APPROVALS		TITLE:	
INIT	DATE	BACKLINE 112 PRE-AMP	
DESIGNED: R.A.G.	10/01/01	SIZE	DRAWING NO: 406-0150-A
DRAWN: R.A.G.	10/8/01	B	PART NO: 206-0150-A
ELEC:		COMPANY: GALLIEN-KRUEGER	
MECH:		FILENAME: 6150A Backline 112 Preamp.sch	
Q/A:			
RELEASED:

Bill of Materials Backline 112/110 Preamp 206-0150-A

Customer Name:		Gallien-Krueger		Current Rev #:		A1		New ECO Rev #:		A2	
Model:		Backline 110/112				Page:		1		Of: 1	
Assembly Description:		Preamp Assembly		Originator:		Bob Gallien					
Assembly Numbers:		206-0150-A1		Approved by:							
				Effective Date:		12/21/2001					
Effective				Document Update				Date		Initials	
<input checked="" type="checkbox"/>	All in Process	<input checked="" type="checkbox"/>	Next Buy	<input type="checkbox"/>	Artwork						
<input type="checkbox"/>	All in Service	<input checked="" type="checkbox"/>	Next Production Run	<input type="checkbox"/>	Assembly Dwg.						
<input type="checkbox"/>	All in Stock	<input type="checkbox"/>		<input type="checkbox"/>	Auto Insert Pgm						
Beginning Serial Number:				<input type="checkbox"/>	Board Artwork						
Reason For Change				<input checked="" type="checkbox"/>	BOM	#####					AV
The Overdrive B channel has too much g

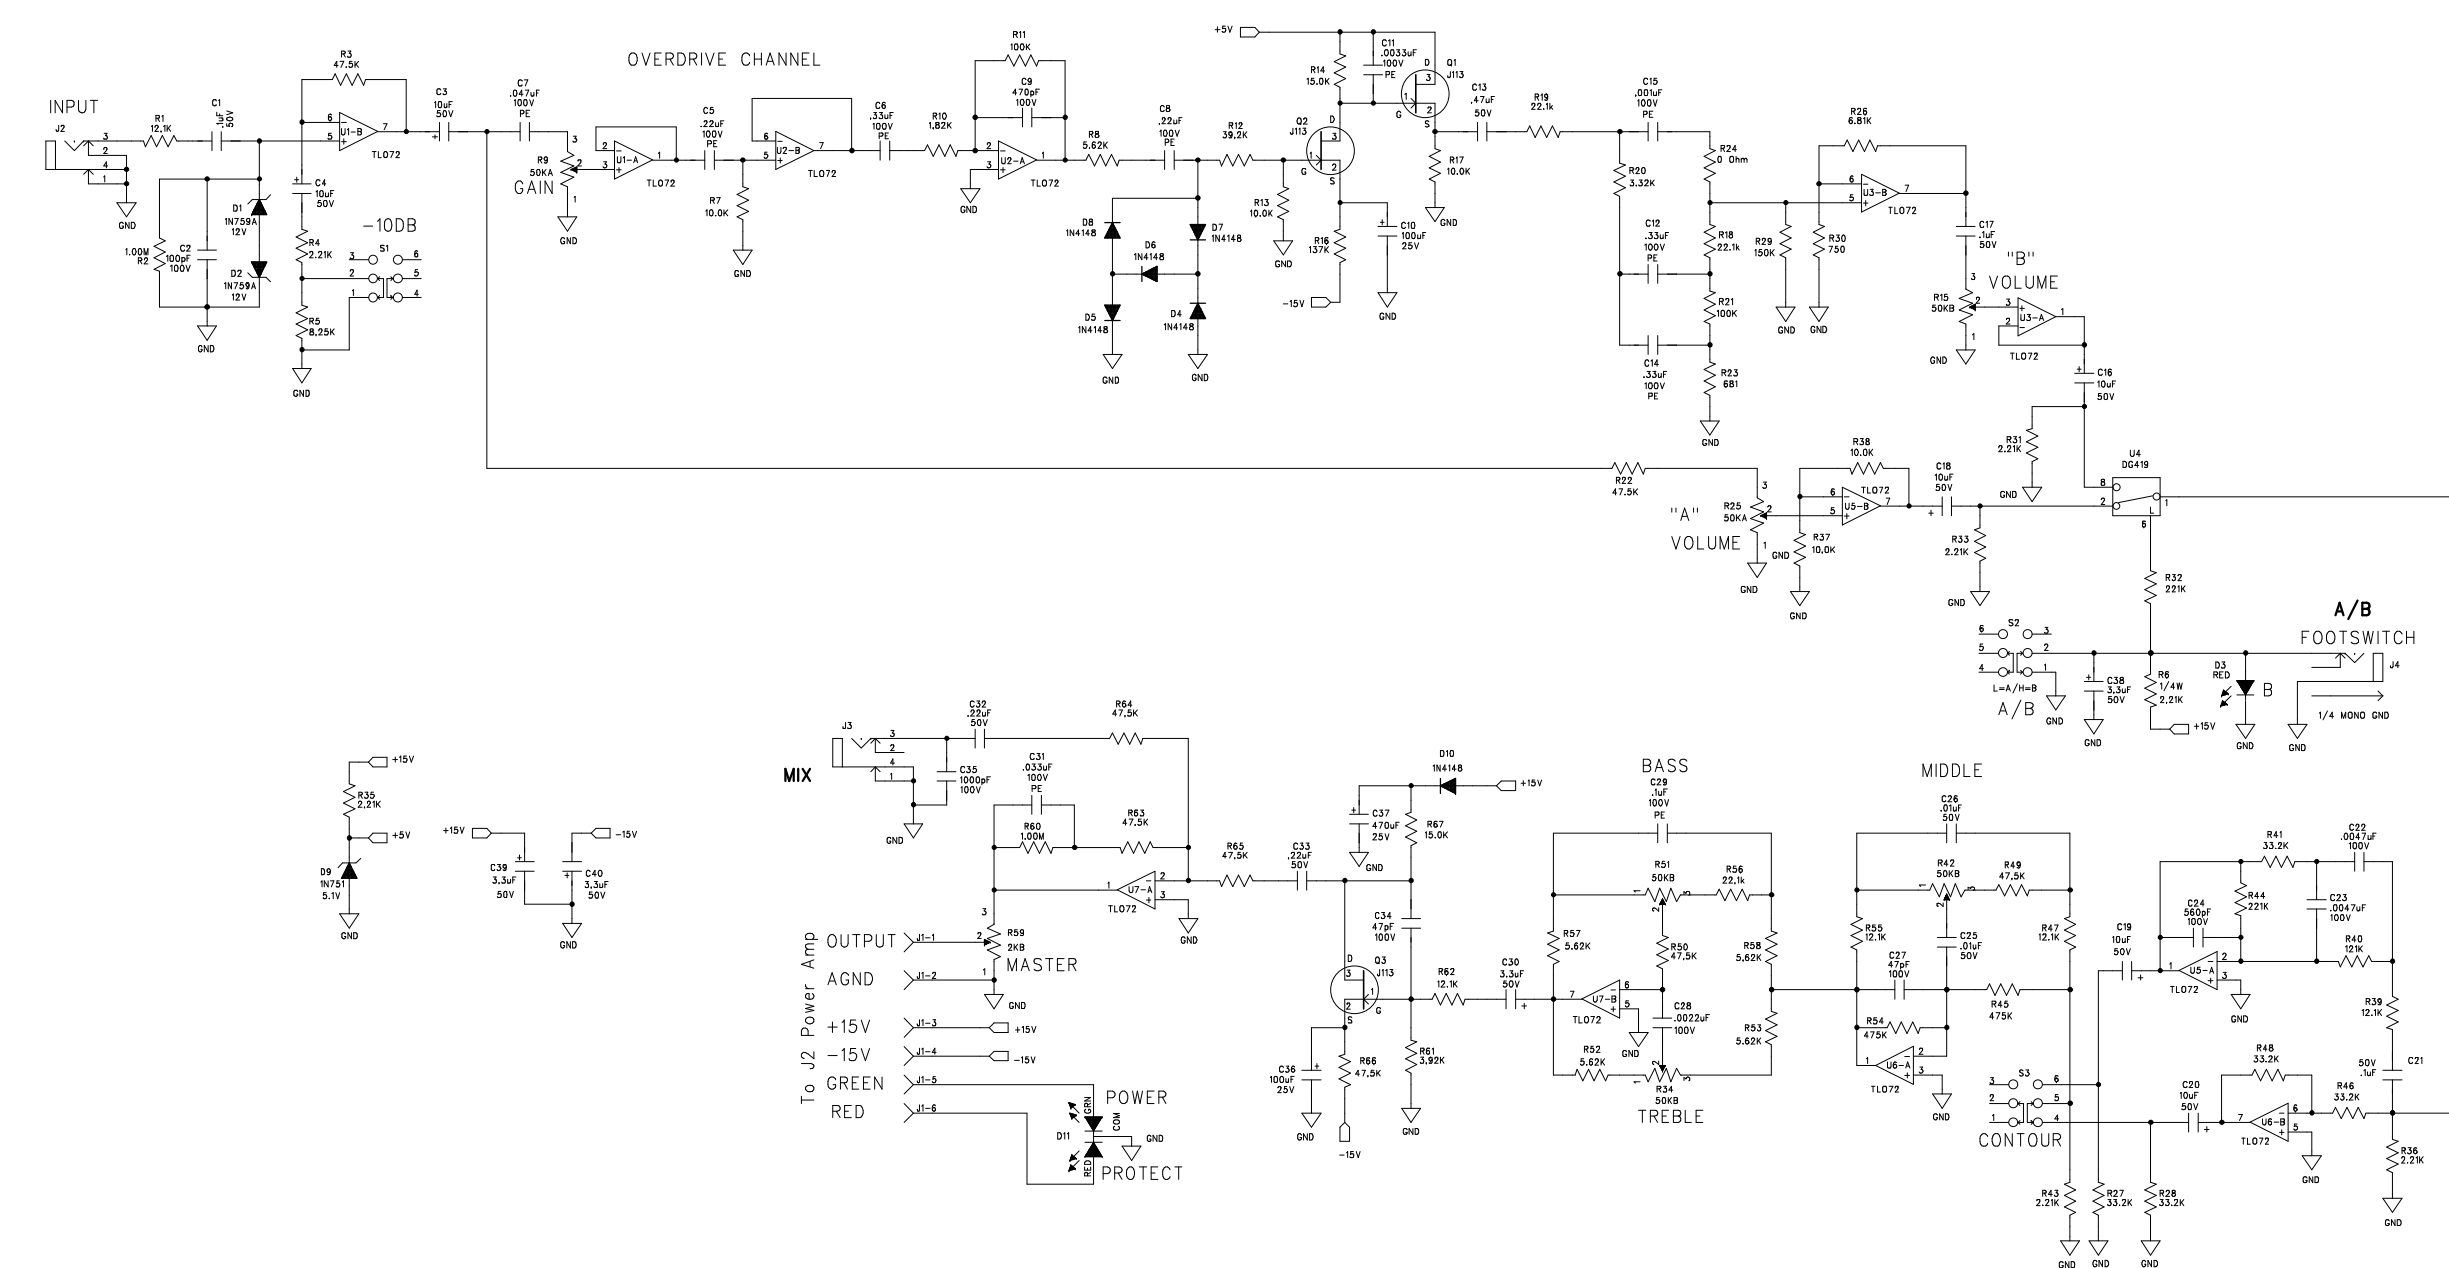
1. Q1 & Q2 POWERED FROM +5V.
2. OUTPUT MIXER ADDED.
3. POP CIRCUIT FOR CONTOUR
4. POP CIRCUIT FOR A/B SWITCH
5. REMOVE LED DRIVE CKT.
6. OP-AMP FOR CONTOUR OFF
7. OUTPUT BASS BOOST CKT ADDED.
8. NOTCH MODIFIED
9. TAPER OF GAIN & VOL B CHANGED.

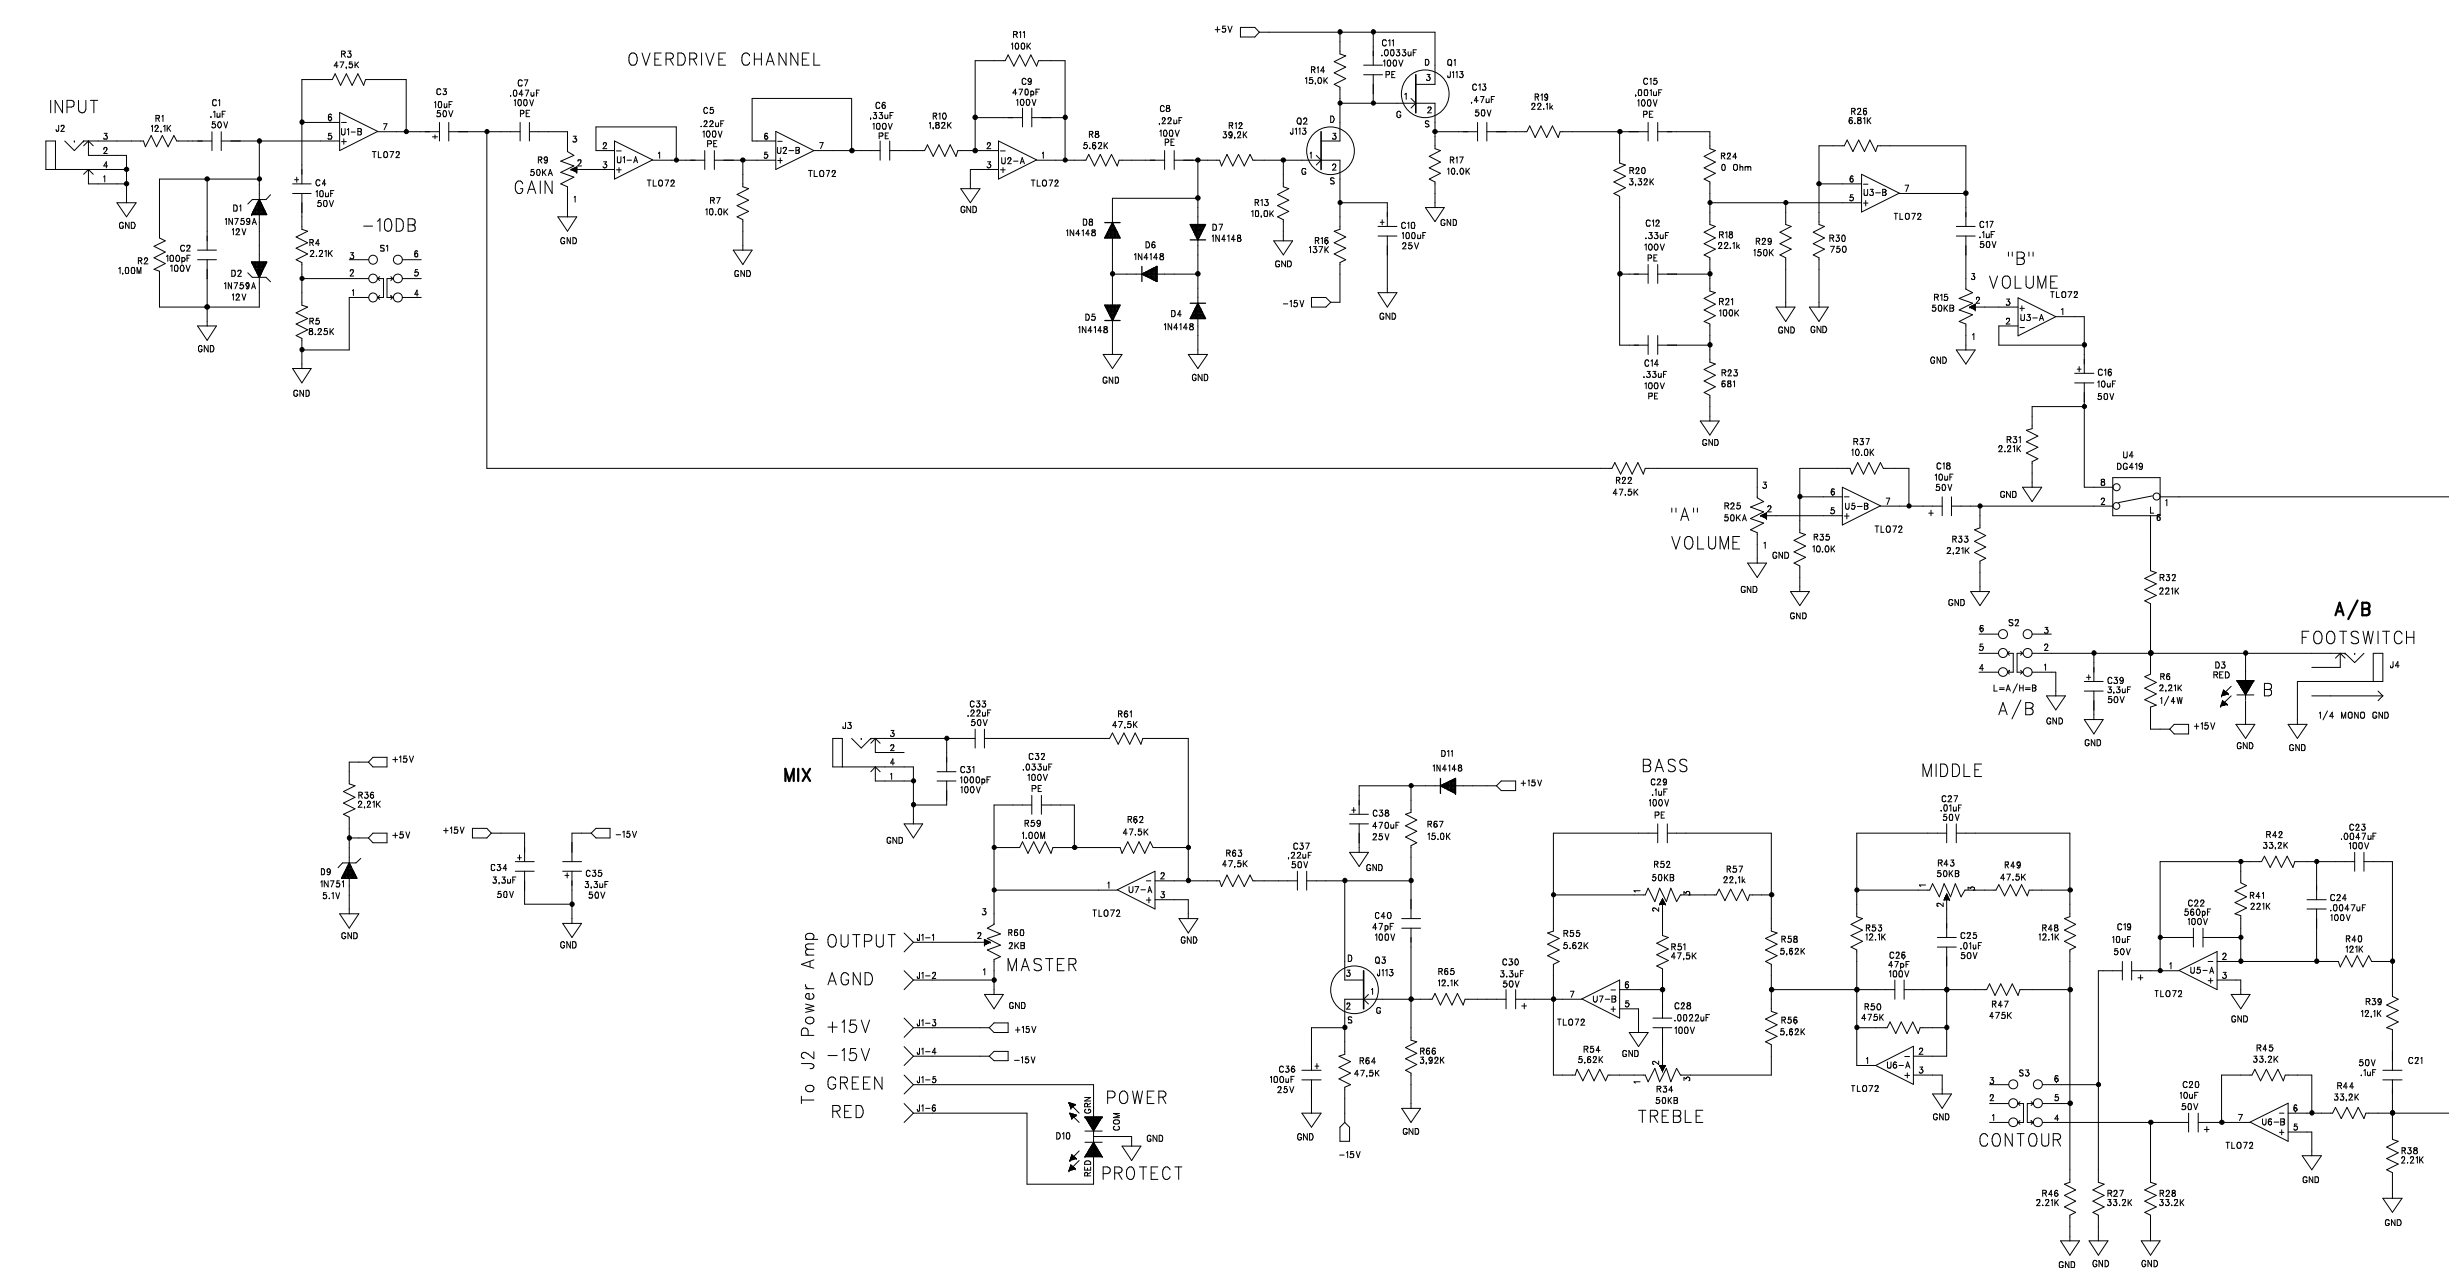
1. Moved parts and added notch for Transformer.		APPROVALS		TITLE: BACKLINE 112 PRE-AMP	
INIT	DATE			REV.	
DESIGNED: R.A.G.	10/01/01				
DRAWN: R.A.G.	11/13/01			DRAWING NO: 406-0150-A1	A1
ELEC:				PART NO: 206-0150-A1	
MECH:				COMPANY: GALLIEN-KRUEGER	
Q/A:				FILENAME: 6150A1 Backline 112 Preamp.sch	
RELEASED:

DWG #420-0150-A1

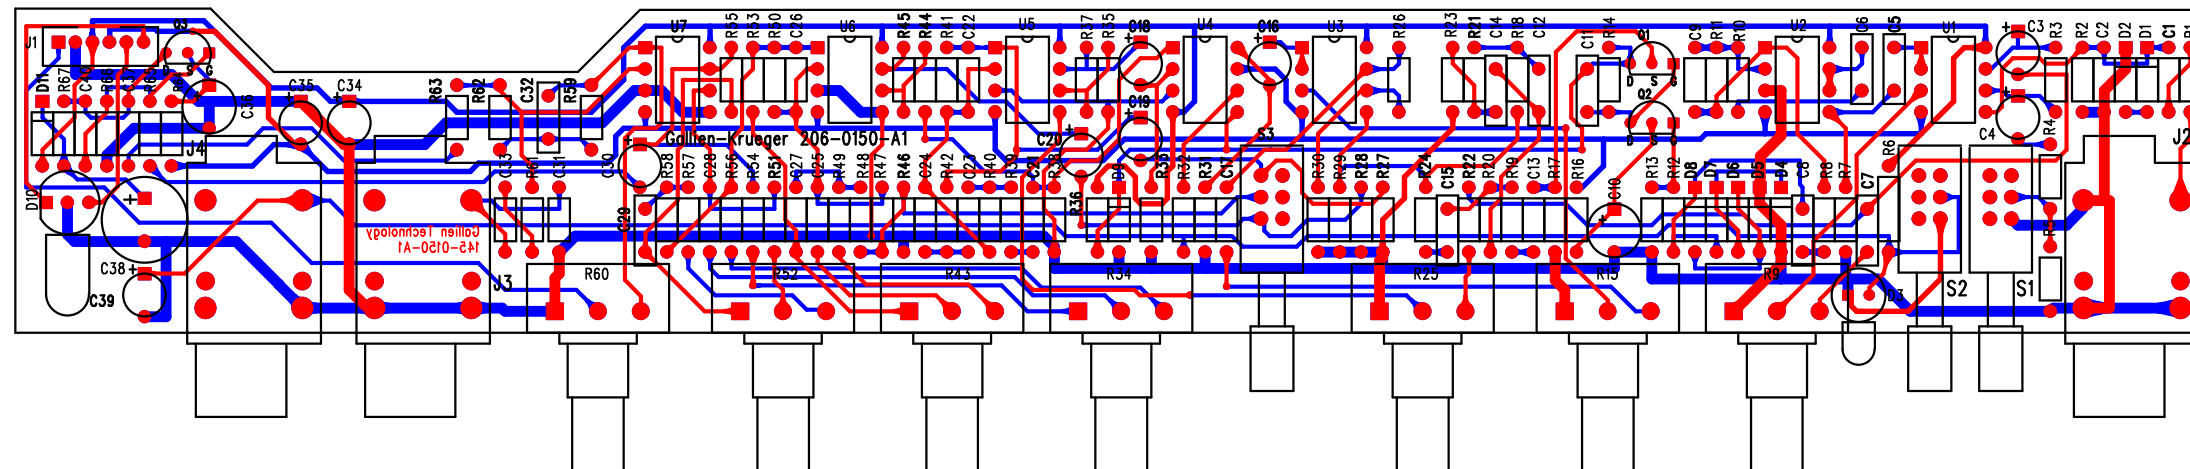
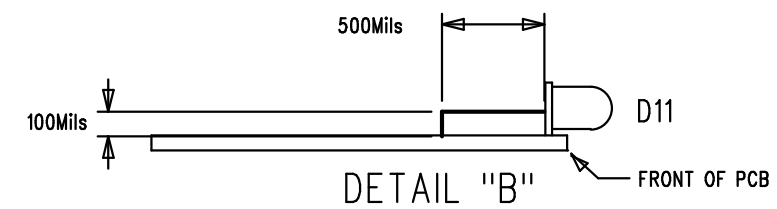
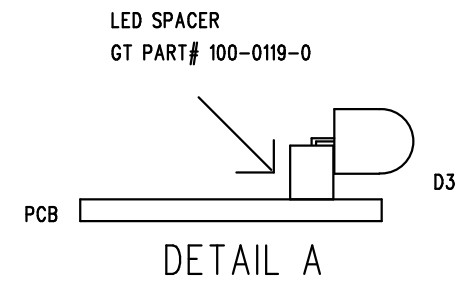
NOT VALID UNLESS STAMP IS RED	gallien technology		2240 PARAGON DRIVE SAN JOSE CA. 95131 VOICE: 408-441-8081 FAX: 408-441-8085	
	APPROVALS		TITLE: BACKLINE 112 PREAMP BD	
Put notch in board for transformer.	INIT	DATE	SIZE	REV.
	DESIGNED: R.A.G.	10/01/01	DRAWING NO: 405-0150-A1	A1
	DRAWN: R.A.G.	11/13/01	PART NO: 145-0150-A1	
	ELEC:		COMPANY: GALLIEN-KRUEGER	
LAYER DESCRIPTION: TOP SIDE IS NOT TO BE MOUNTED	MECH:		FILENAME: 5150A1 Backline 112 Preamp.pcb	
	GERBER FILE NAME: 5150A1.pcb

APPROVALS		DATE		TITLE	
INT		10/10/01		BACKLINE 110/112 PRE-AMP	
DESIGNED: R.A.G.		12/21/01	HR	DRAWING NO:	406-0150-A2
DRAWN: R.A.G.			B	PART NO:	206-0150-A2
ELEC:				COMPANY:	GALLIEN-KRUEGER
MECH:				FILENAME:	6150A2 Backline 112 Preamp.sch
S/A:					
RELEASED:

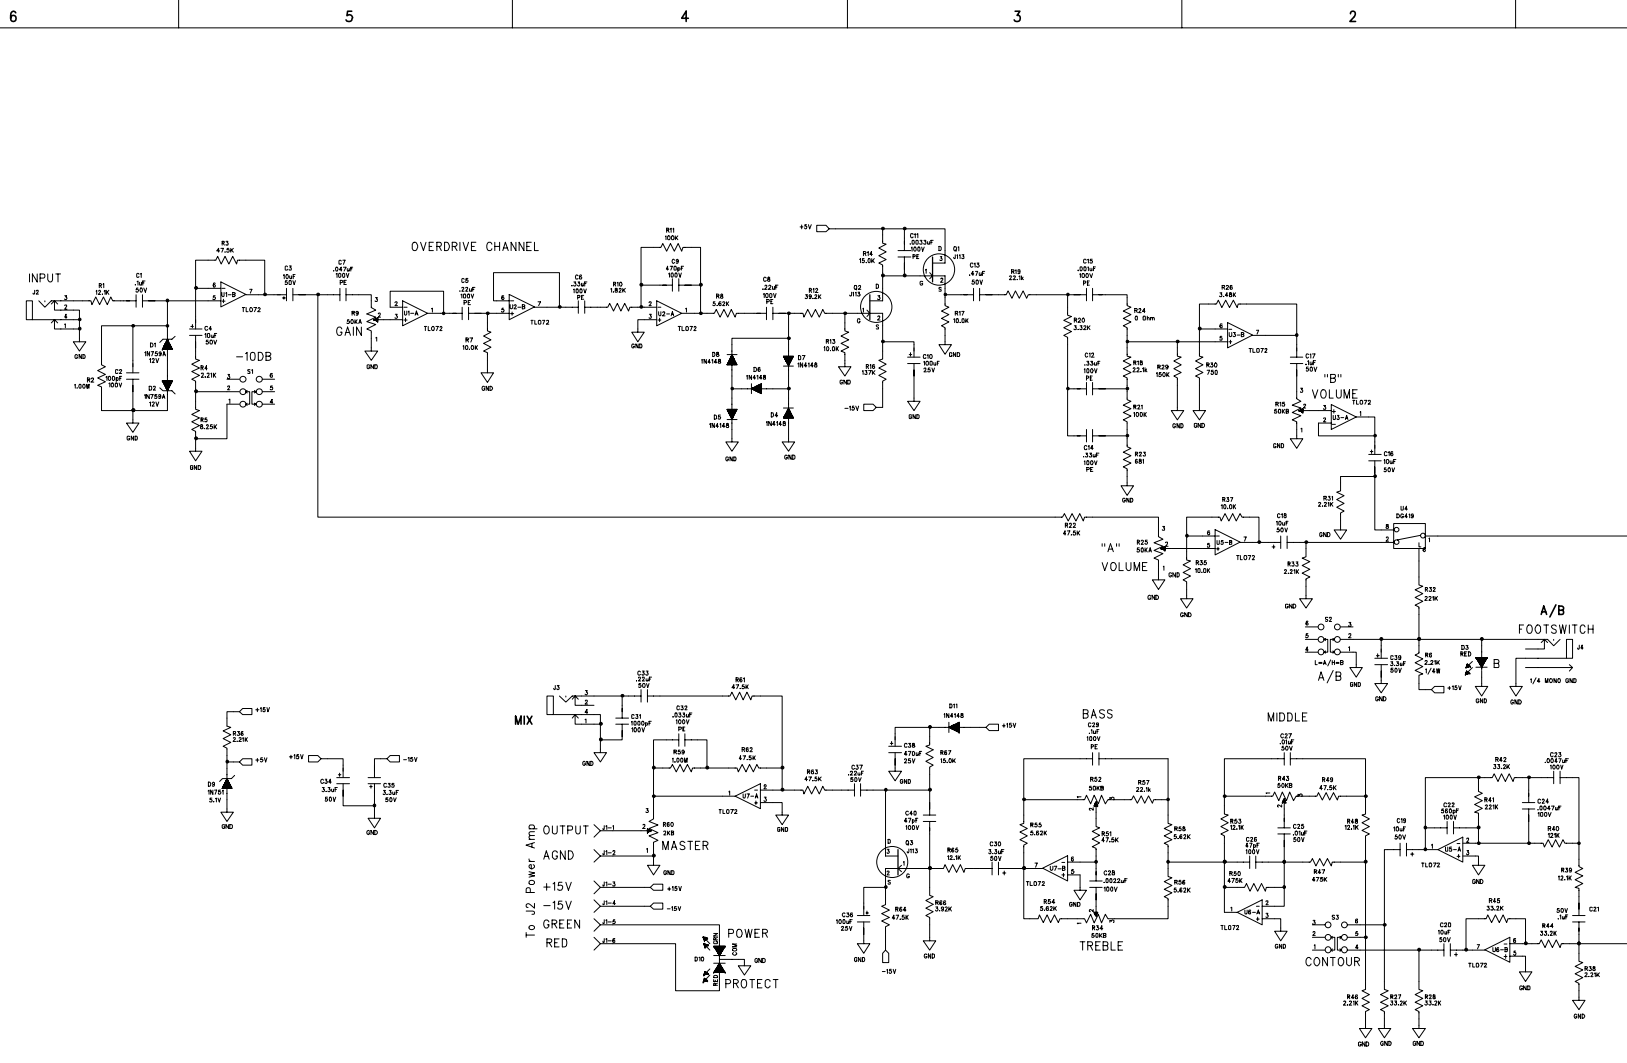
Match volume levels between A and B channels				<input type="checkbox"/>	Costing						
No Rev change is required for the 303 and 290 levels since all units have shipped with this modification.				<input type="checkbox"/>	Fab Drawing						
				<input type="checkbox"/>	Inspection Proc.						
				<input checked="" type="checkbox"/>	Part Master File						
				<input type="checkbox"/>	Punch Program						
				<input checked="" type="checkbox"/>	Schematic	#####					AV
				<input type="checkbox"/>	Service Manual						
				<input checked="" type="checkbox"/>	Test Procedure						
				<input type="checkbox"/>							
				<input type="checkbox"/>							
				<input type="checkbox"/>							
<input type="checkbox"/>	Continued on ECO Supplement Page			<input type="checkbox"/>							
Description Of Change				Distribution				Date		Initials	
Reduce gain by a factor of two.				<input type="checkbox"/>	Accounting						
Change R26 from 6.81k to 3.48k				<input type="checkbox"/>	Assembly

1. Reduced gain in overdrive channel

For product in current production add a 6.81K resistor in parallel with R26 on the back of the board.				<input type="checkbox"/>	Customer						
				<input checked="" type="checkbox"/>	Engineering						
				<input type="checkbox"/>	Fabrication						
				<input checked="" type="checkbox"/>	Incoming Q.C.						
				<input type="checkbox"/>	Planning						
				<input checked="" type="checkbox"/>	Production Eng.						
				<input checked="" type="checkbox"/>	Purchasing						
				<input type="checkbox"/>	Q.A.						
				<input type="checkbox"/>	Receiving						
				<input type="checkbox"/>	Service						
				<input type="checkbox"/>	Vendor						
				<input checked="" type="checkbox"/>	Test						
				<input type="checkbox"/>							
<input type="checkbox"/>	Continued on ECO Supplement Page			<input type="checkbox"/>	Drawing(s) attached						
Part Number	Description	Parts Added		Parts Deleted							
		Qty	Ref. Designator	Qty	Ref. Designator

060-6812-0	6.81k, 1/8W, 1%			1	R26						
060-3482-0	3.48k, 1/8W, 1%	1	R26
